ACCESSION NBR: 8111230484 DOC. DATE: 81/10/27 NOTARIZED: NO DOCKET #  
 FACIL: 50-397 WPPSS Nuclear Project, Unit 2, Washington Public Power 05000397  
 AUTH. NAME: AUTHOR AFFILIATION  
 BOUCHEY, G. D. Washington Public Power Supply System  
 RECI. NAME: RECIPIENT AFFILIATION  
 SCHWENCER, A. Licensing Branch 2

SUBJECT: Forwards response to Reactor Sys Branch request for addl info re open items, per 811007 telcon. Response will be incorporated into FSAR Amend 21.

Subject: SUPPLY SYSTEM NUCLEAR PROJECT NO. 2  
NRC QUESTIONS AND OPEN ITEMS  
REACTOR SYSTEMS BRANCH

FIGURE 211213-1

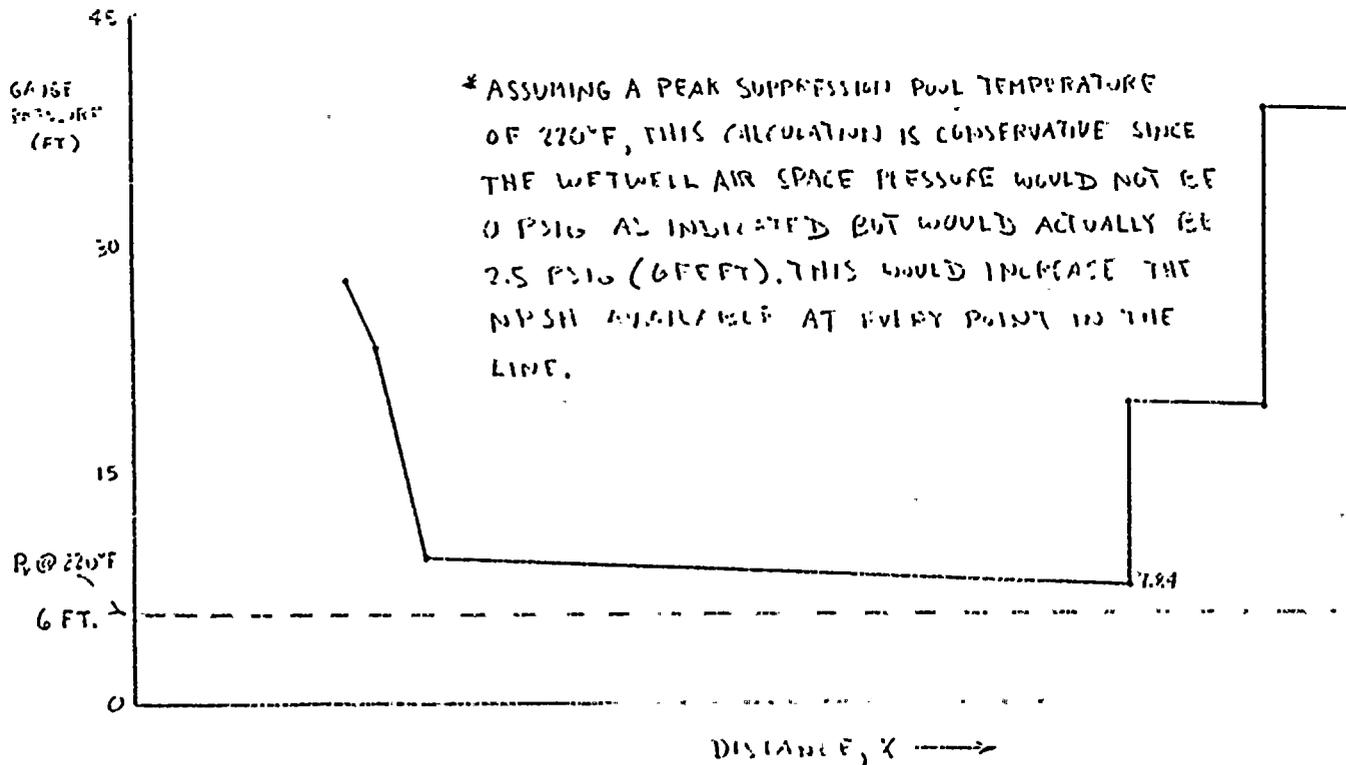
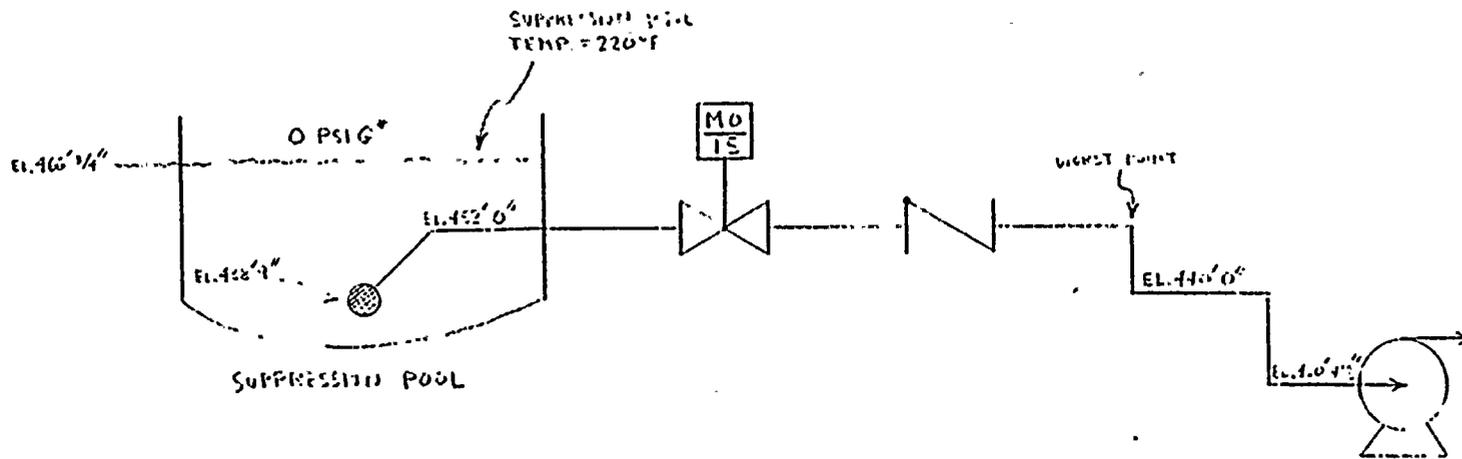
Calculations of NPSH available to ECCS pumps in BWRs are normally provided with reference to the pump suction. We are concerned that under certain post-accident conditions the potential may exist for damage to ECCS pumps from cavitation because of local flashing in the system suction lines. The potential can result, for example, from local elevation changes in the piping runs. Calculations of NPSH available at the pump suction may erroneously assume liquid continuity up to the point of pump suction. Provide an analysis with calculations which demonstrates that the NPSH available at all points in all safety-related pump suction piping is adequate to preclude local flashing and pump cavitation under the worst postulated conditions.

The ECCS systems which are involved are the RHR, LPCS, and HPCS systems. The RCIC system is also considered. Supply to the suction of the pumps comes from condensate storage or from the suppression pool. In the worst case, pump suction would be drawn from the suppression pool at high temperatures.

For each system, assuming a peak suppression pool temperature of 220°F, a plot was prepared of available NPSH versus location in the pump suction line. The HPCS system represents the worst case and is illustrated in Figure 211.213-1. At the worst point in the system, the available NPSH is 7.8+ feet which is above the 6 feet required to prevent flashing in the line. This calculation is conservative since the actual wetwell air space pressure at 220°F would be 2.5 psig (6 feet) not 0 psig as assumed per Regulatory Guide 1.1. This would provide an additional 6 feet of available NPSH at any point in the pump suction line.
